Serial No.: 09/902,023

For: Method for Constructing A
Multistory Building

THIRD PROPOSED DRAWING AMENDMENT

FIG. 1

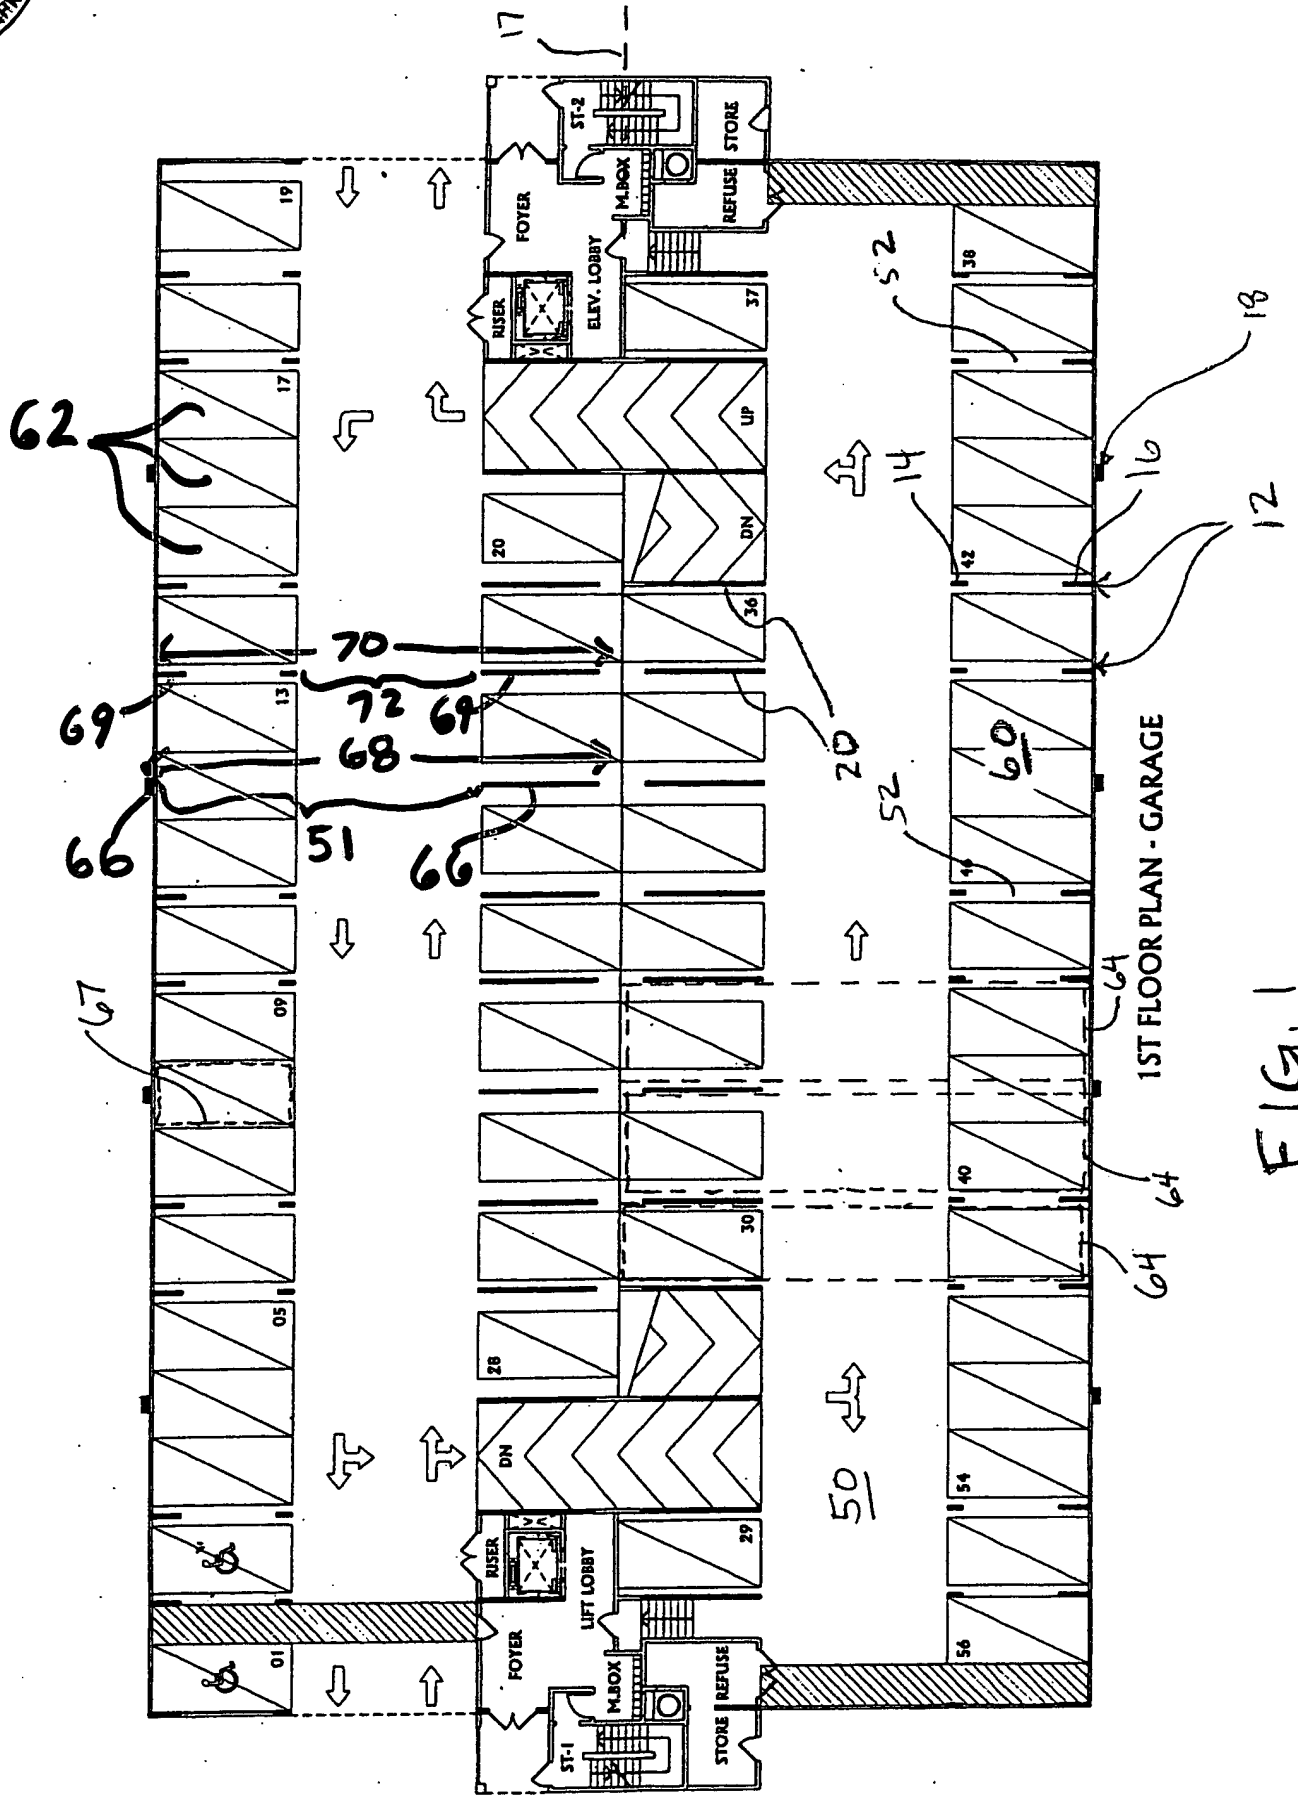
The Examiner objected to the drawings on the grounds Figure 1 does not illustrate reference numeral 62 and that certain other reference numerals are not shown on Figure 1. A third Proposed Drawing Amendment is submitted herewith, in which the reference numerals in question have been added to Figure 1. The Proposed Drawing Amendment also includes an amendment correcting an error in Figure 5.

In response to the Office Action dated October 25, 2004, Applicants submit the attached sheet containing proposed amendments to Figures 1 and 5. Specifically, several reference numerals have been added to Figure 1 and a correction has been made to Figure 5.
